RE: Comments of the Minnesota Department of Commerce, Division of Energy Resources

Docket No. E002/M-18-239

2017 Annual Electric Service Quality Report (Report) submitted by Northern States Power Company, d/b/a Xcel Energy (Xcel or the Company).

Comments of the Minnesota Department of Commerce Division of Energy Resources

Figure 1: Metro East Historic CAIDI Performance

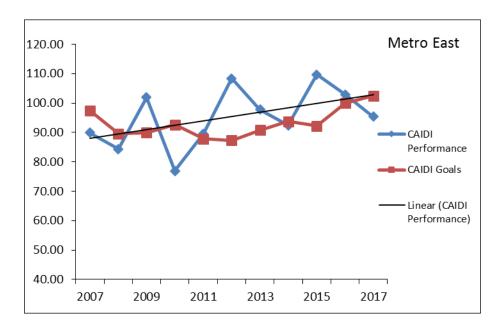
At this time, it appears that Xcel's SAIDI and SAIFI performances are holding steady or trending toward improvement; however, over previous years, there had been, and somewhat continues to be, a clear trend of a decline in CAIDI performance in all four work centers. Figures 1 through 4 below show CAIDI performance over the previous eleven years for each of Xcel's work centers.⁶

Figure 4: Southeast Historic CAIDI Performance

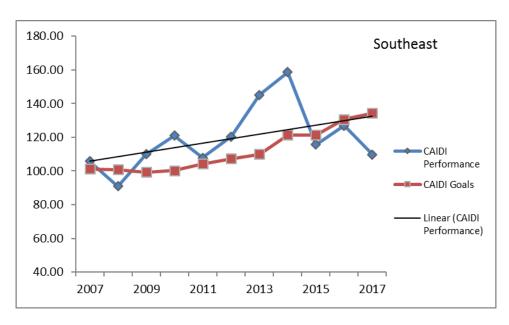
Evaluating this CAIDI trend against generally steady or improving SAIDI and SAIFI performance indicates that Xcel has reduced the number of overall outage minutes as well as the frequency of outages, but customers experiencing outages are without power for a longer period of time, on average. Improving SAIDI and SAIFI performances indicate improvement to the system as a whole.

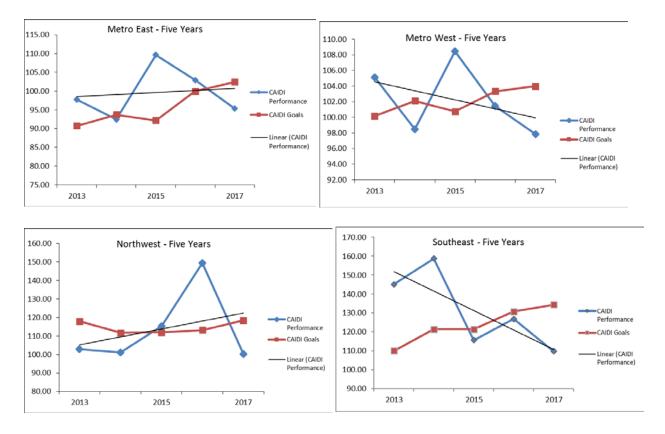
The Department realizes that CAIDI can fluctuate in any given work center, due to extreme weather, accidents, and other events outside of the control of the Company. It can also be difficult to balance improvement in CAIDI with fluctuations in SAIDI and SAIFI performance. Since 2012, Xcel's CAIDI performance has remained mostly steady or improved in three of its four work centers.

These recent trends may indicate that the efforts instigated by Xcel's CAIDI improvement team since 2014 are improving the Company's CAIDI performance. The Department notes that SAIDI and SAIFI reflect Xcel's system reliability, while CAIDI is more customer-focused. Similar to CAIDI, CELI and CEMI are also customer-experience focused. Until CAIDI performance reflects solid stabilization or improvement, Xcel's reporting of CEMI and CELI provides some additional insight into customers' reliability experience. Therefore, the Department recommends that the Commission continue to require Xcel to report CELI and CEMI as discussed further below.
